TARRAWONGA LIFE OF MINE MODIFICATION – RESPONSE TO REQUEST FOR ADDITIONAL INFORMATION

Table 1 – Response to Response to Supplementary DPIE Request for Additional Information

Re: **Tarrawonga Coal Mine MOD 7 (PA11_0047
Mod 7) Request for Additional Information**

Figure 1. Location of flood bund relative to pit extent and alluvial boundary

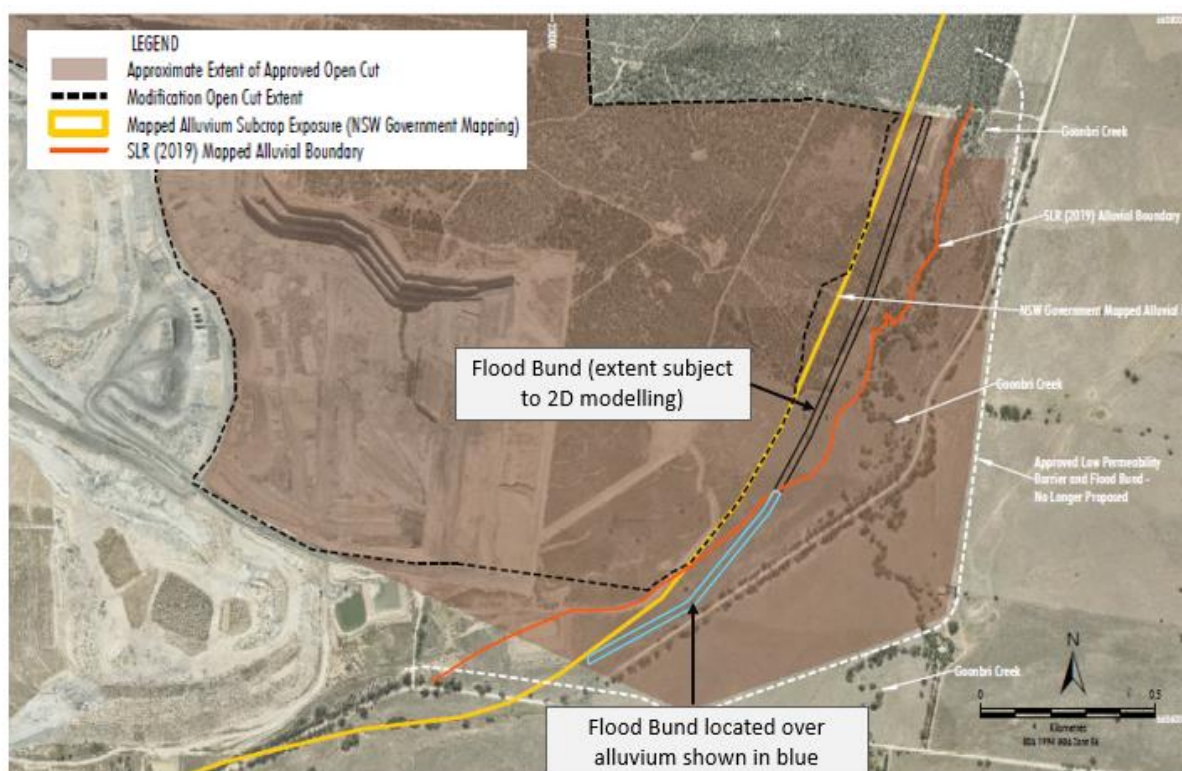
1. clarification of the alignments/setbacks of the pit crest from the mapped alluvium and flood bund;
2. consideration of the potential for leakage towards the pit and/or post mining void via the alluvium due to floodwater ponding against the flood bund and/or mapped alluvium;
3. consideration of potential pathways via fractured rock from blasting; and
4. consideration of any additional reasonable and feasible mitigation measures (such as keying the flood bund into the bedrock where it is located on the alluvium).

The design flood bund has a length of about 750 m where it overlies mapped alluvium (Figure 1).

Figure 2. Predicted flood extents [after HEC (2019), Figures 29 & 30]

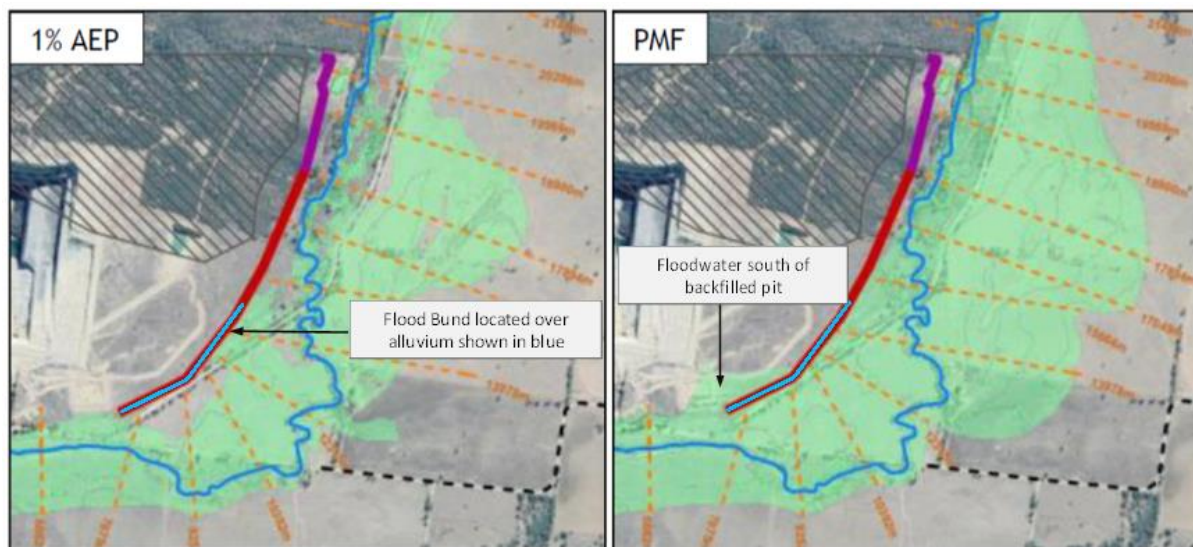
- “...there may be the potential for leakage towards the pit and/or post-mining void via the alluvium and/or fractured rock basement due to flood inundation events...”
- “...the leakage potential is probably low...”
- “...there is no flow path from saturated alluvium towards the pit or final void under normal conditions.”
- “...the source of leakage would have to be from any floodwater that might pond against the flood bund...”
- There is “little opportunity or potential for leakage from a 1% AEP flood event to adequately saturate the subsurface units and convey substantial volumes towards the pit or void.”

The potential for floodwater to abut the flood bund or escape around its southern toe is indicated in **Figure 2** for 1% AEP and PMF events. It is noted that the Modification Report states that the final flood bund design, including its extent, would be subject to 2-dimensional modelling (Whitehaven, 2020).

Figure 2 shows that, for the 1% AEP flood event, floodwater is predicted to abut the flood bund for less than 50% of its length overlying alluvium (about 350 m of 750 m). For the PMF event, floodwater would abut the entire 750 m length and would pass around the toe of the bund (as backwater) and abut the mapped edge of alluvium, but would not abut the backfilled pit.

As shown on **Figure 2**, there would be an opportunity for PMF flood recharge between the pit extent and the southern flood bund, although floodwater would not be in direct contact with spoil. There is negligible opportunity for the 1% AEP flood event.

Figure 2 shows that floodwater is predicted to abut the flood bund for a length of about 350 m for the 1% AEP flood event and for 750 m for the PMF event. Where floodwater abuts the bund, the flood heights calculated by HEC (2019; Table 33) range from 1.4 to 1.5 m for the 1% AEP event and 1.7 to 3.4 m for the PMF event (average 2.3 m).
